# Submittal Review

**Submittal:** Pre-selection Submittal 1-R3

**Clarifier Submittal GA  
Drawing Tanks 8 -  
Spec Section 11451 -  
WesTech Job #  
24946A, B, C**

**Project Name:** WWTP Rehab Secondary Clarifiers **Review Date:**

**SLUDGE WITHDRAWAL RING PLAN VIEW**  
SCALE 0.031  
OUTSIDE OF SLUDGE RING IS CENTERED IN TANK.  
RING MOUNTS DIRECTLY ON CONCRETE FLOOR WITH  
ANCHOR BOLTS BEFORE FLOOR GROUT IS POURED.  
SEE OTHER VIEW FOR ORIENTATION.

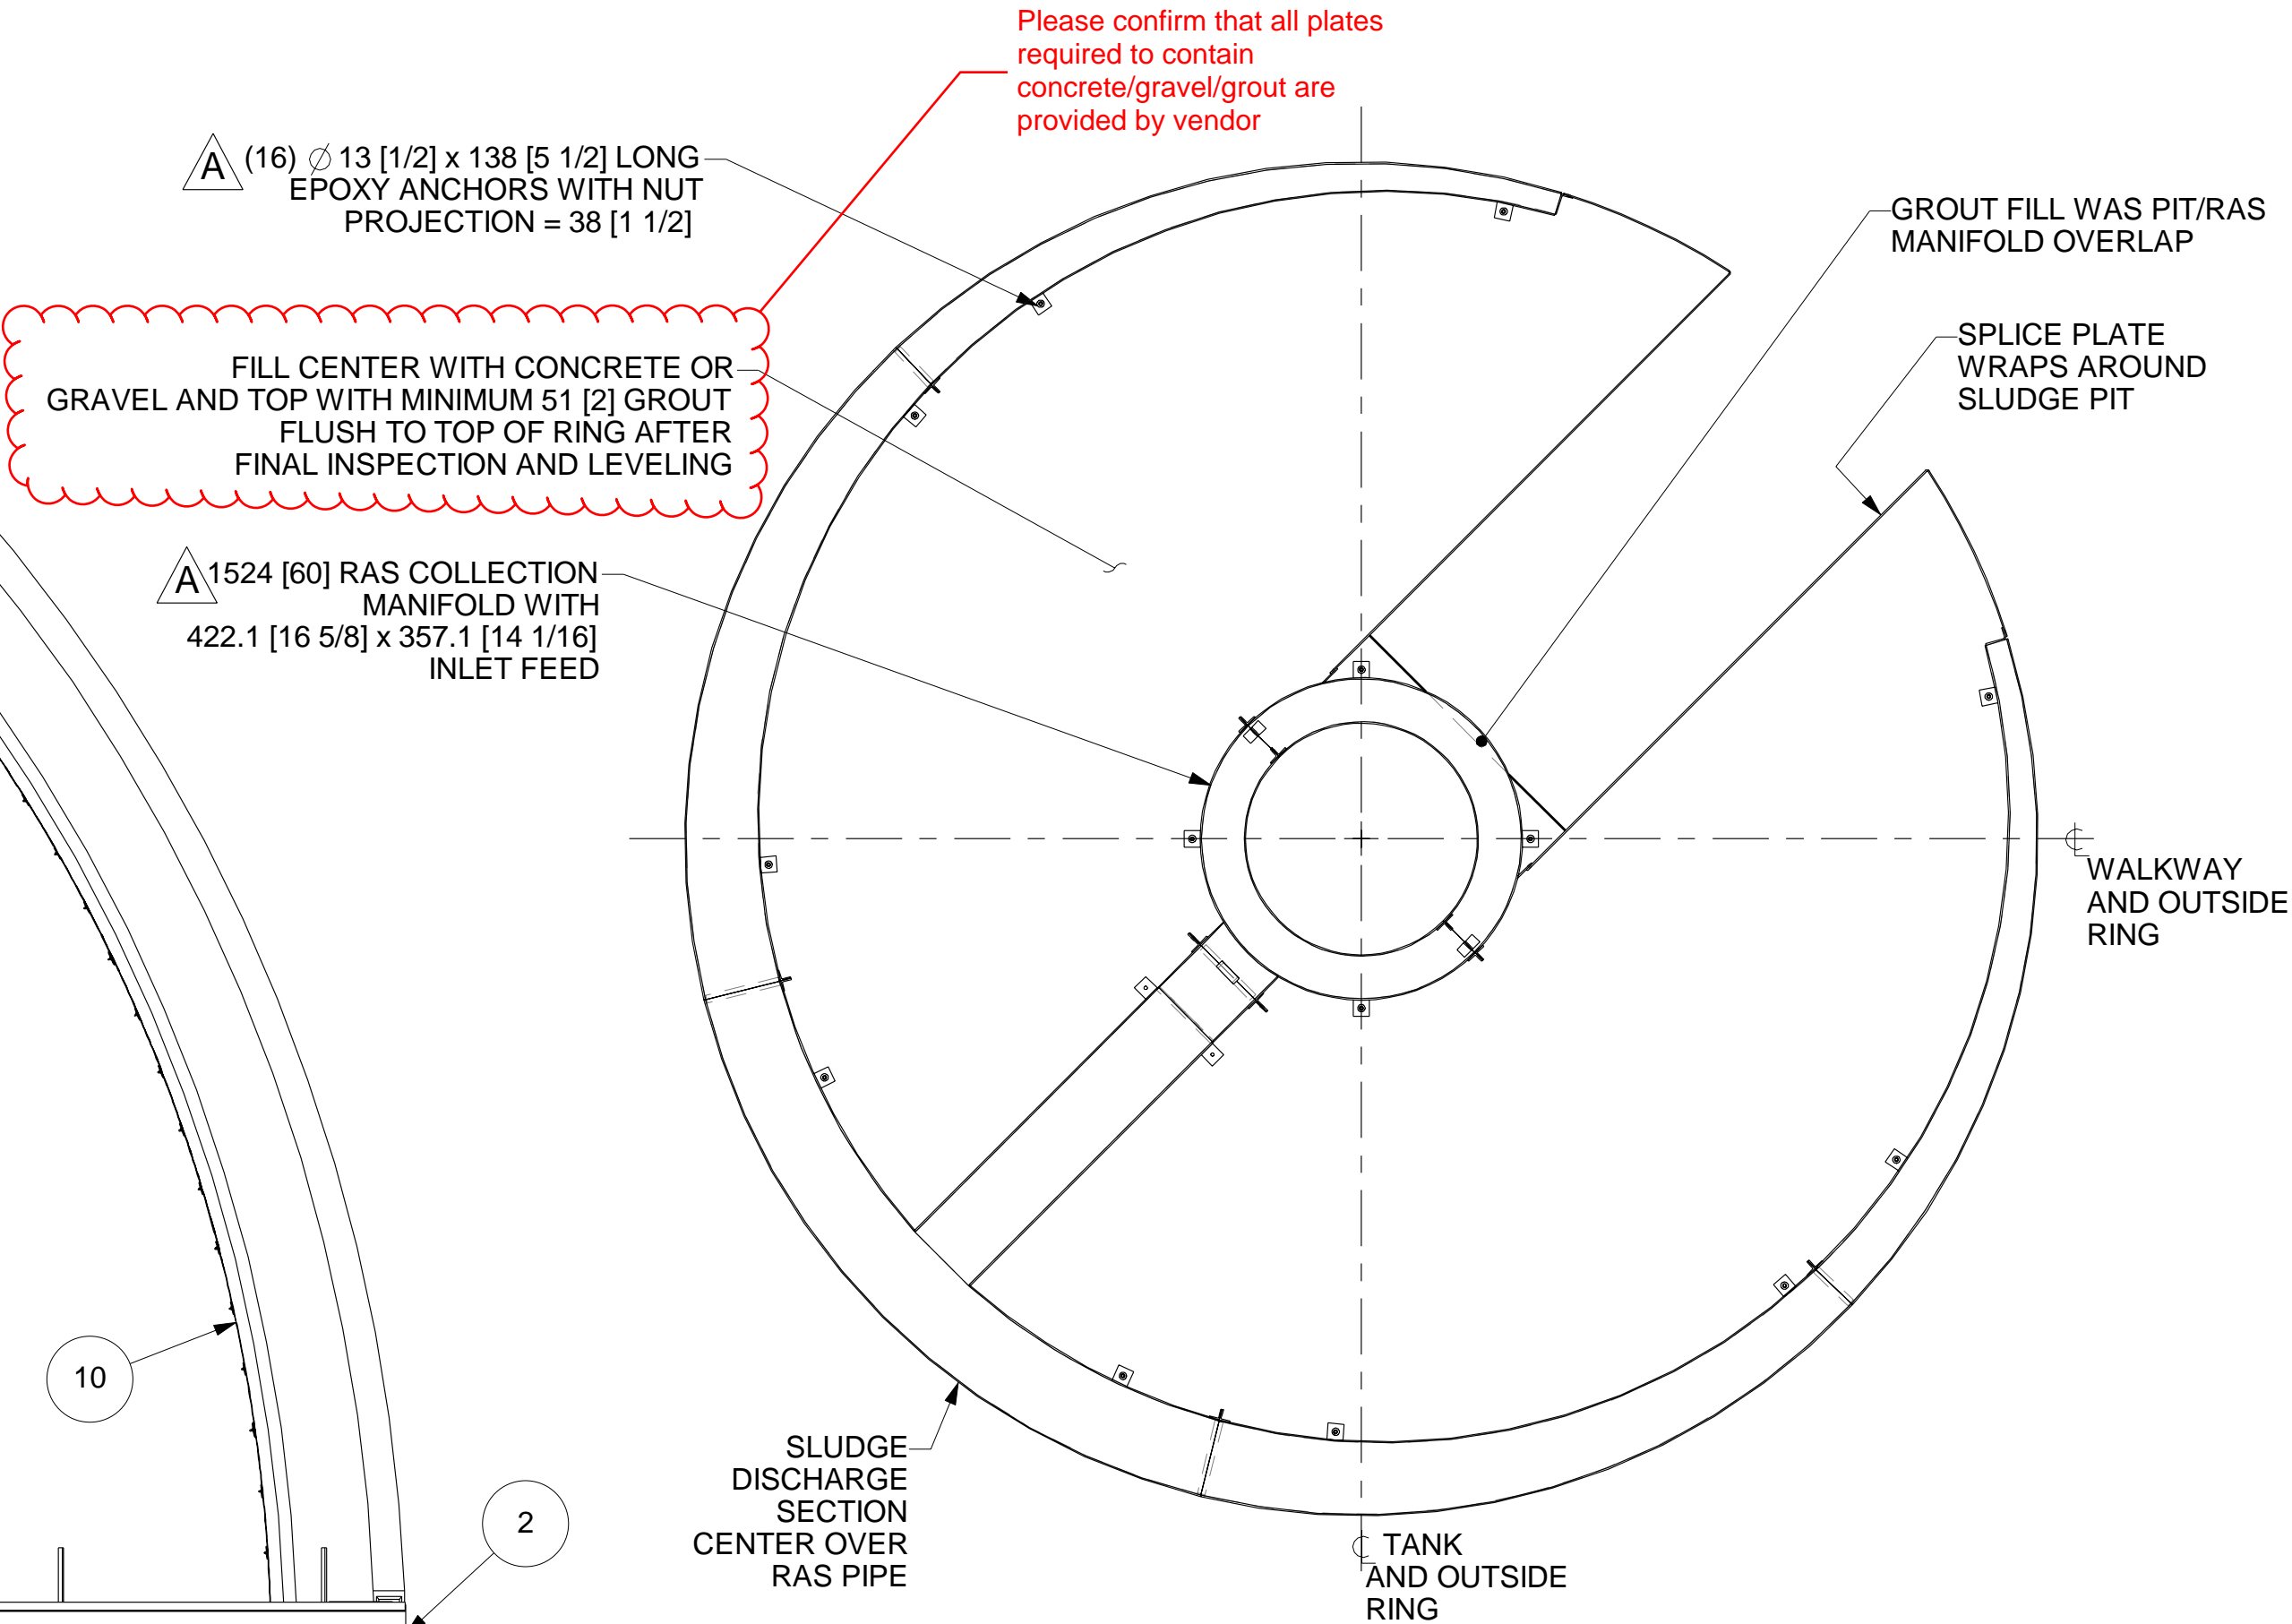
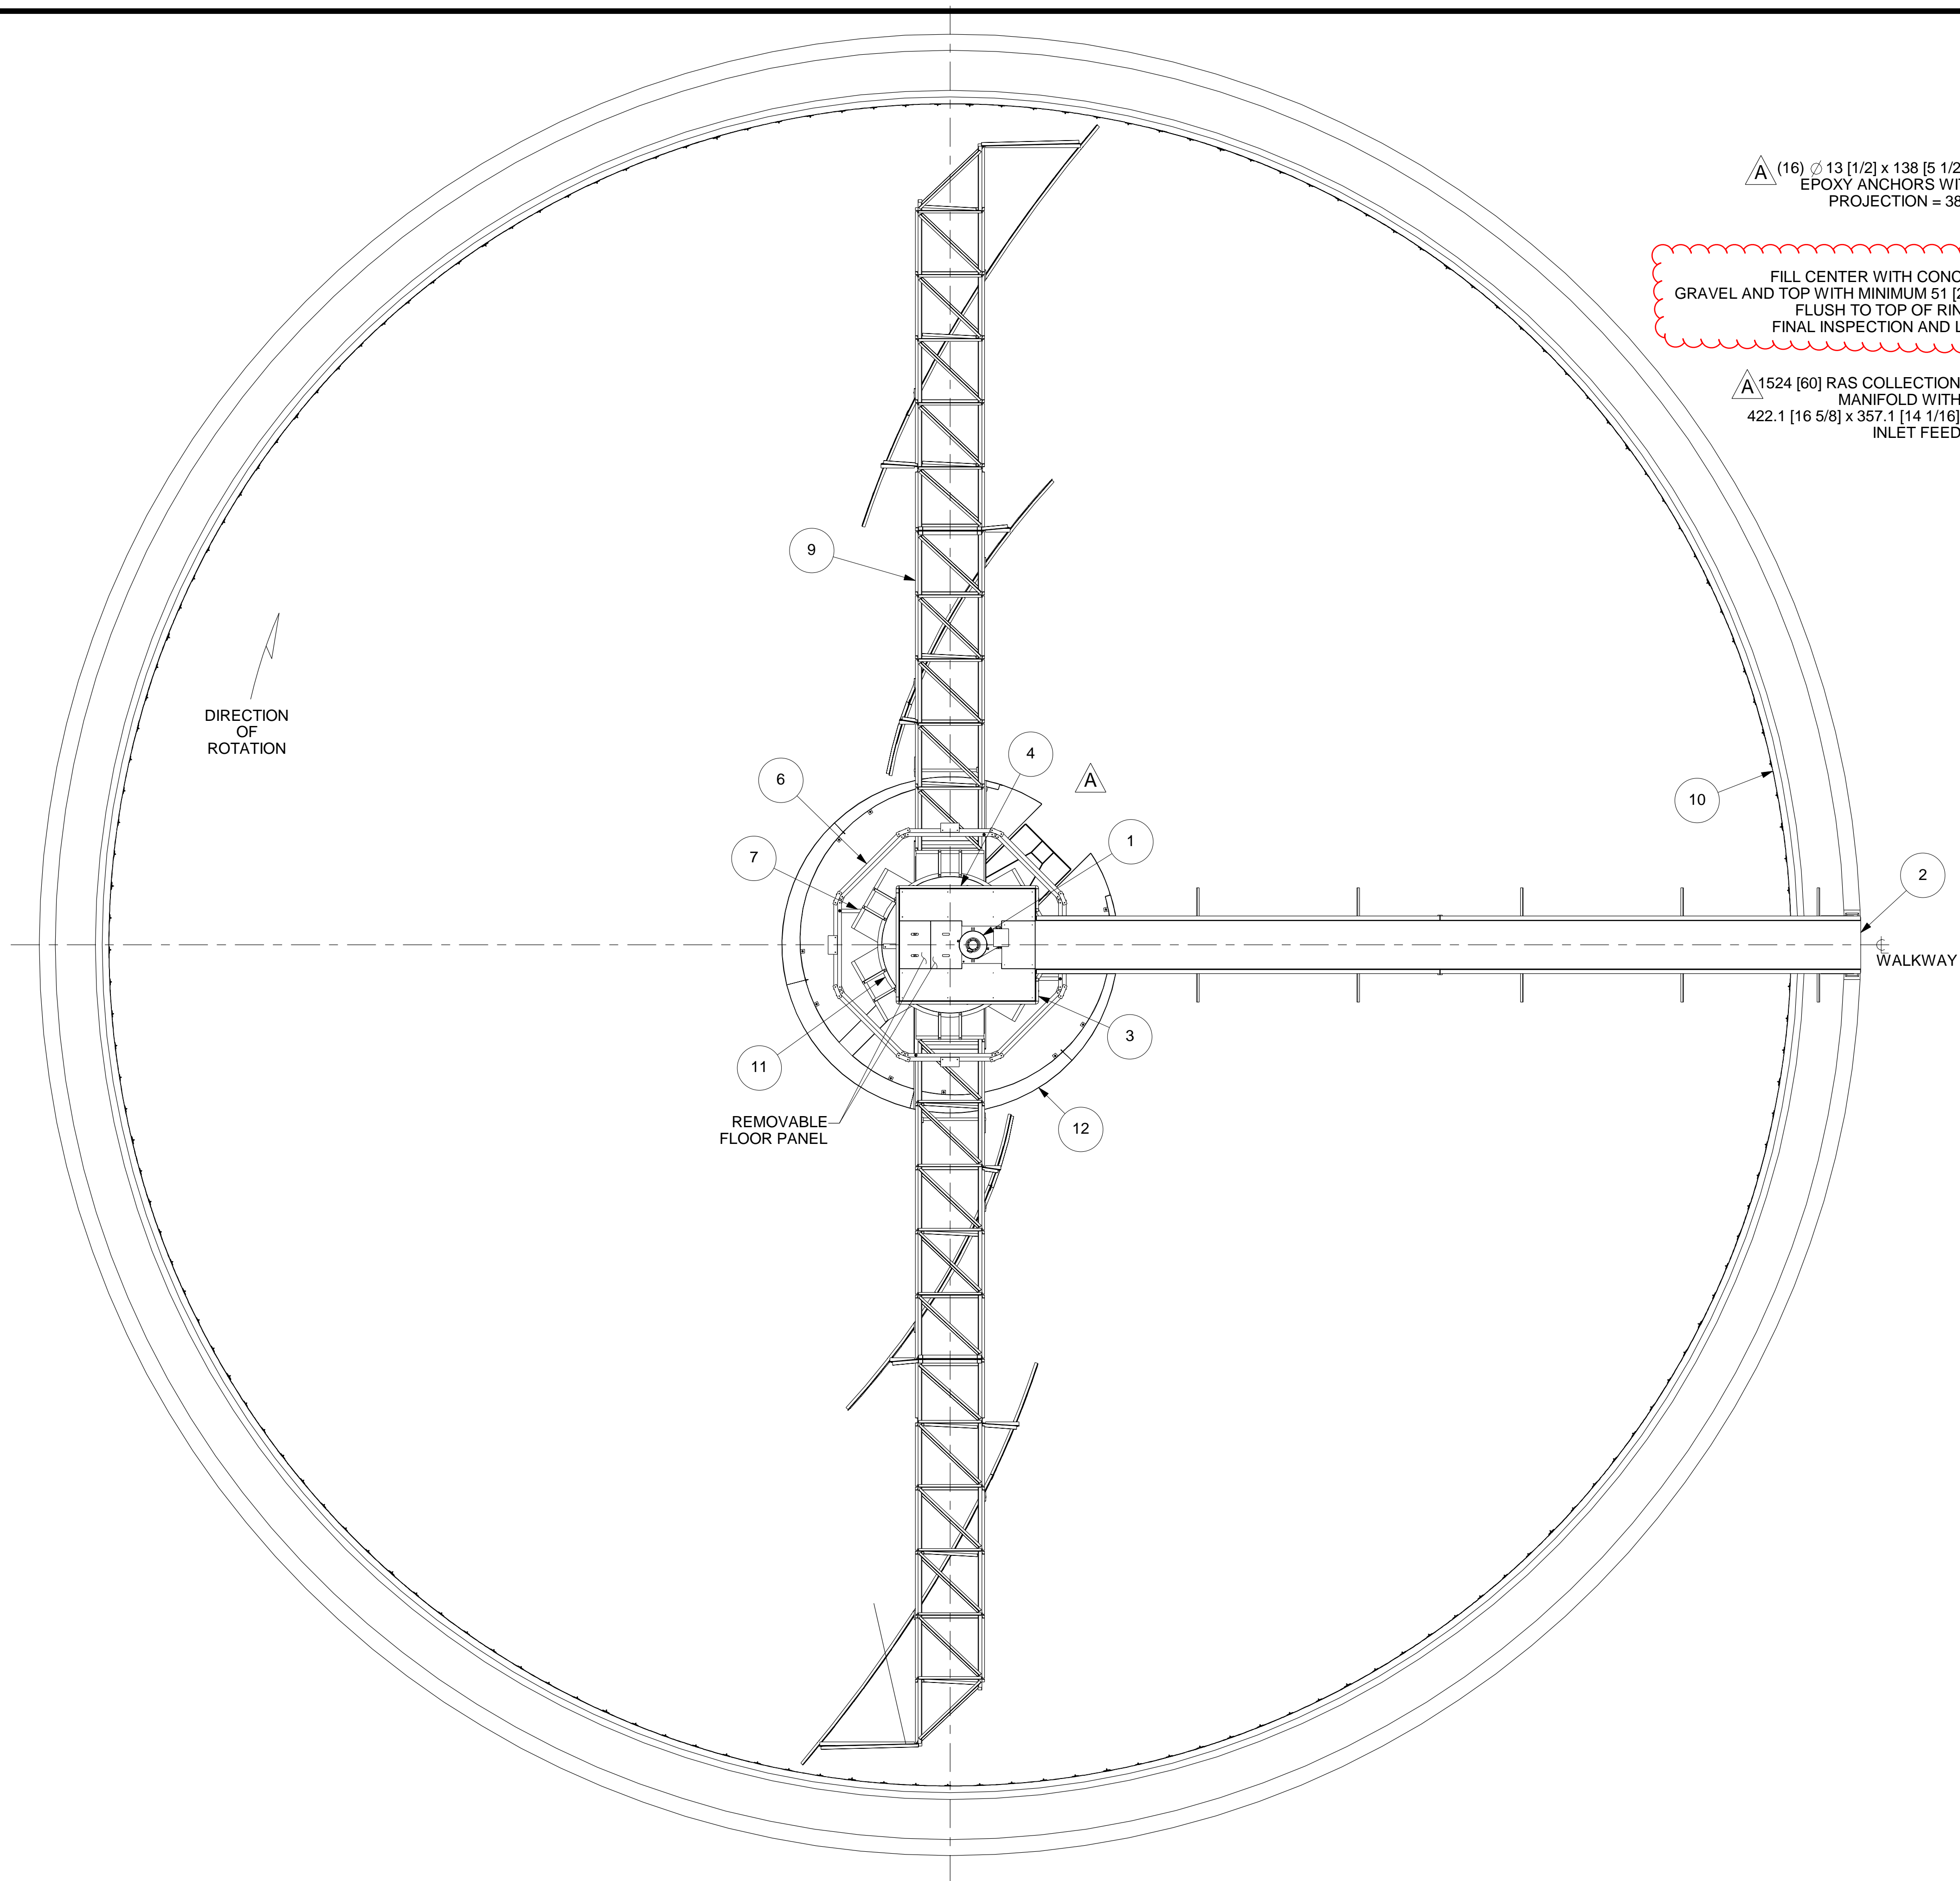
Item	Reference	Reviewer	Comment Status	Comment
1.		ARP / GS	2	Please confirm all forms required to contain concrete, gravel, etc. within the centre sludge withdrawal ring are provided by the vendor. See comment in drawings.
